**R E M A R K S**

Preliminary Amendment  
H. UMEDA et al

FIG. 11

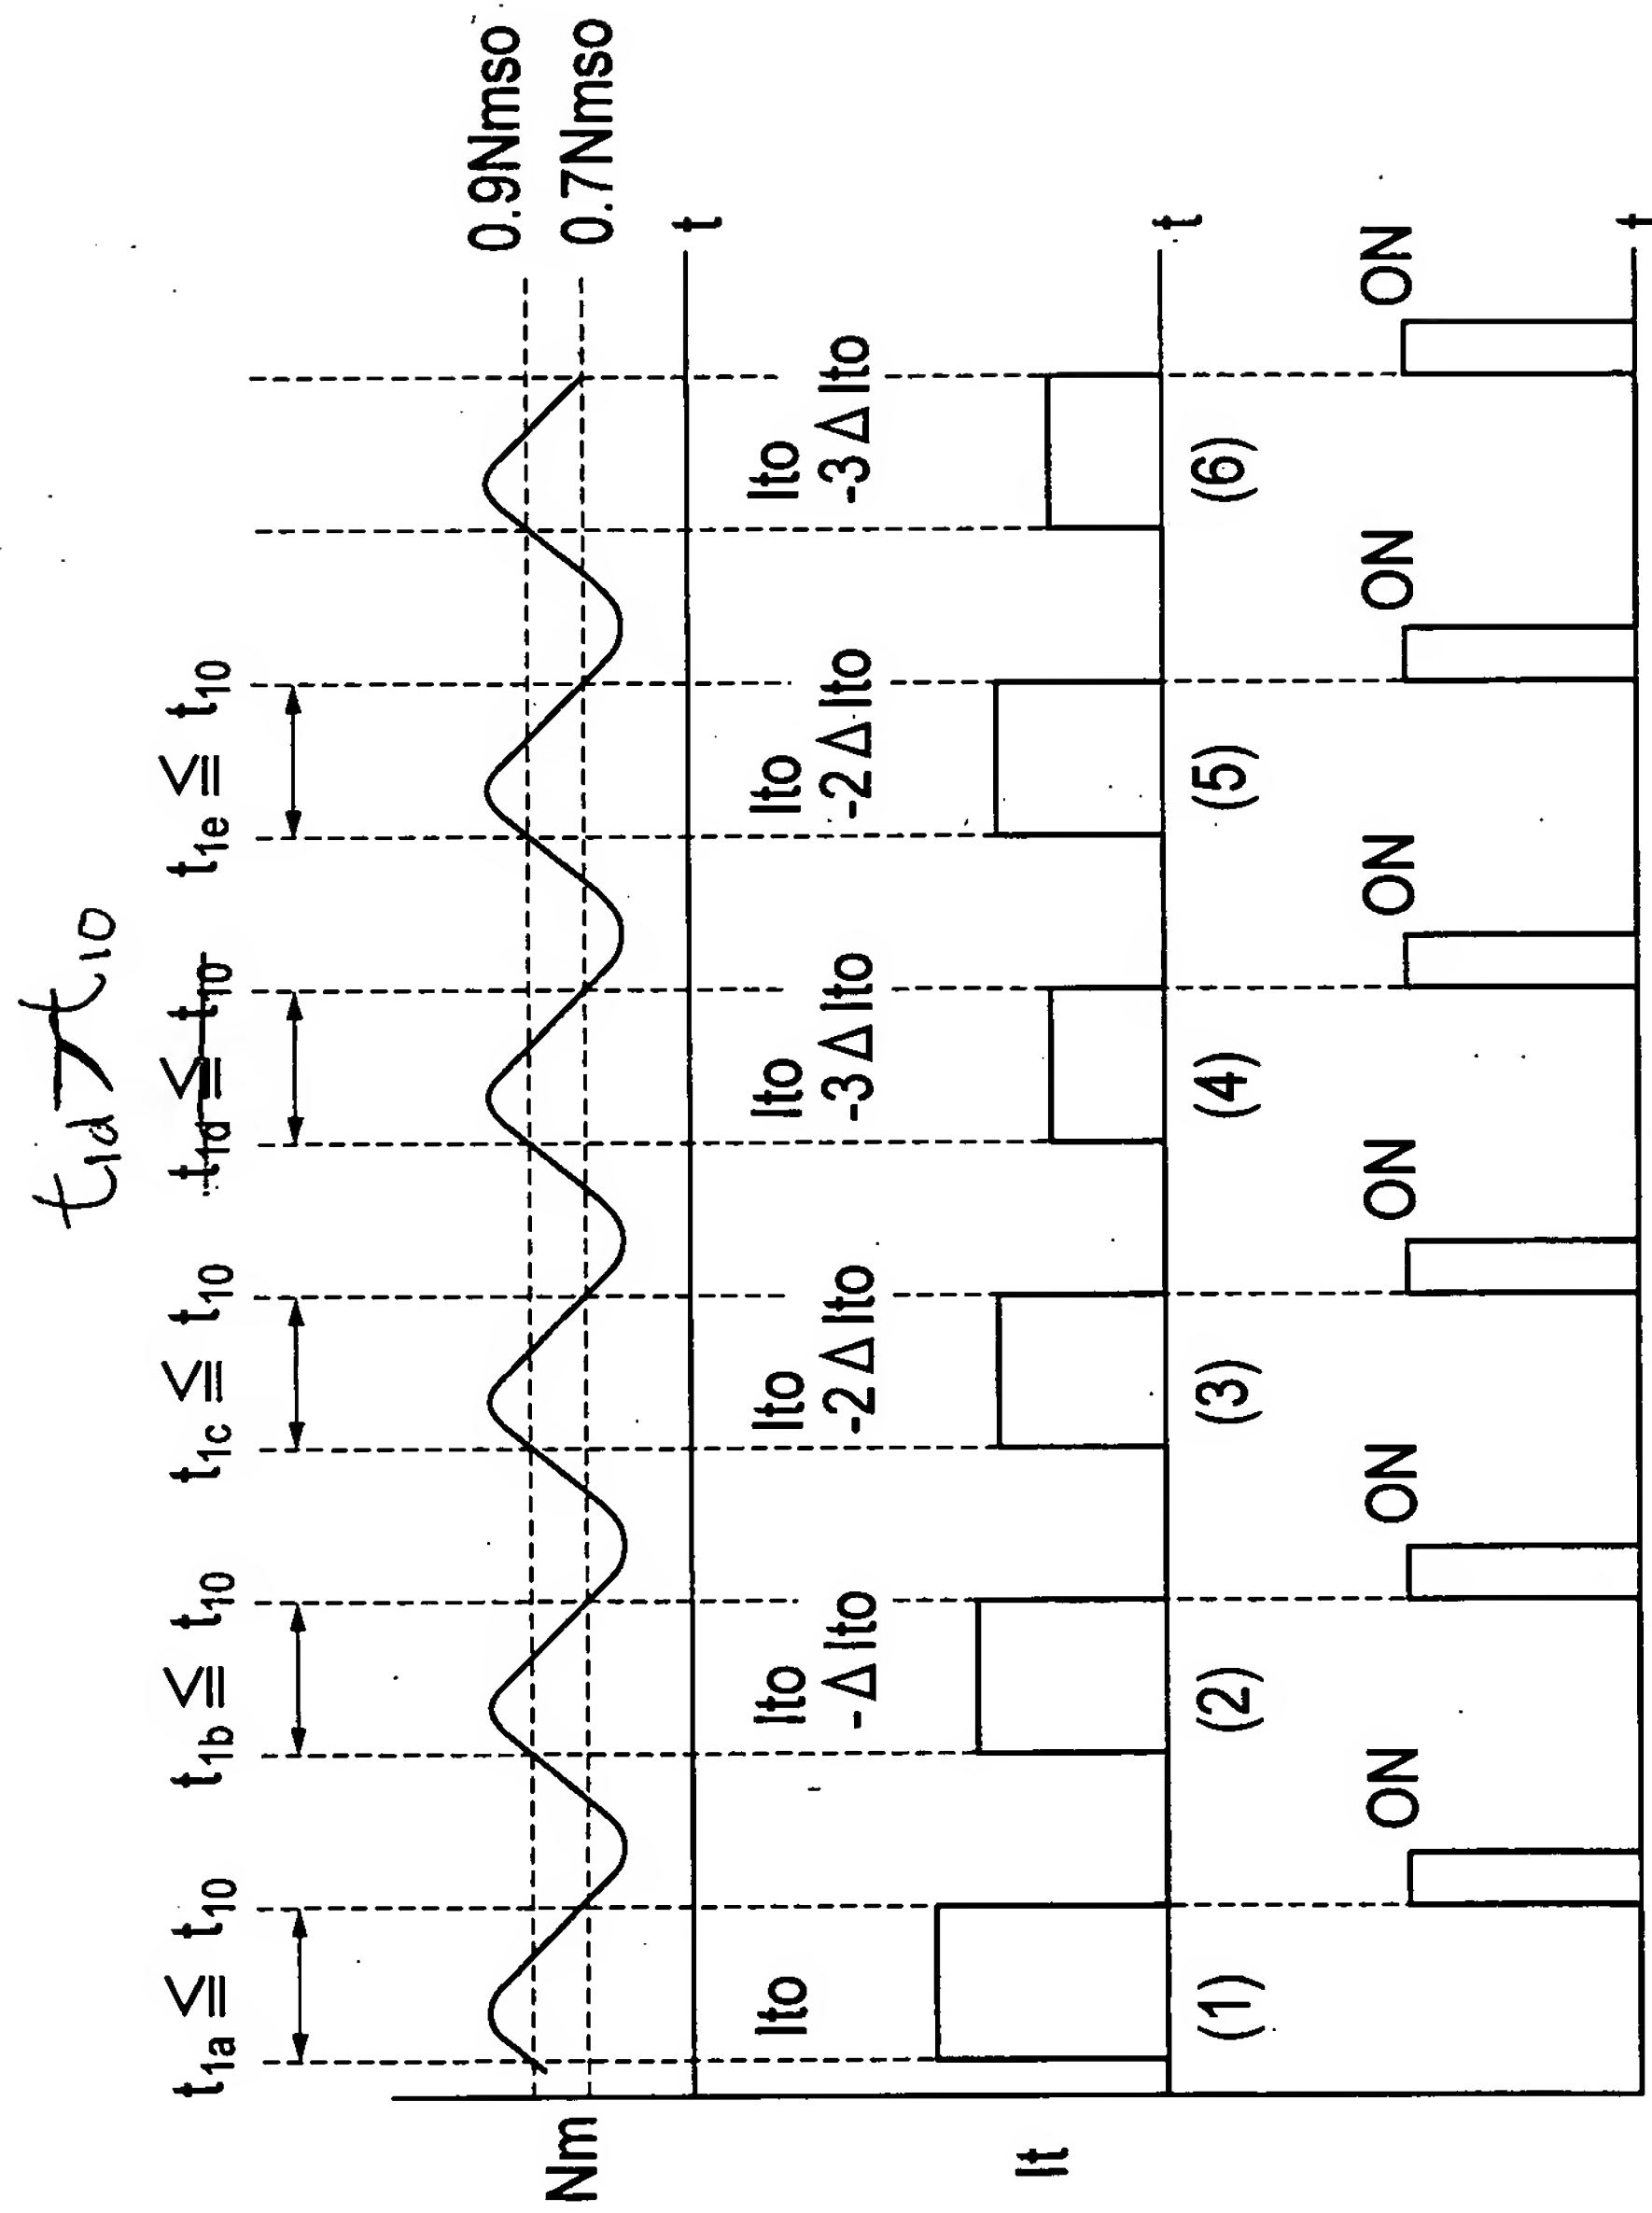
Fig. 11 of the drawings has been amended to change " $t_{1d} \leq t_{10}$ " to " $t_{1d} > t_{10}$ ". No new matter has been added.

Fig. 11 has been amended as indicated on the attached annotated sheet to change " $t_{1d} \leq t_{10}$ " to  $--t_{1d} > t_{10}--$ .
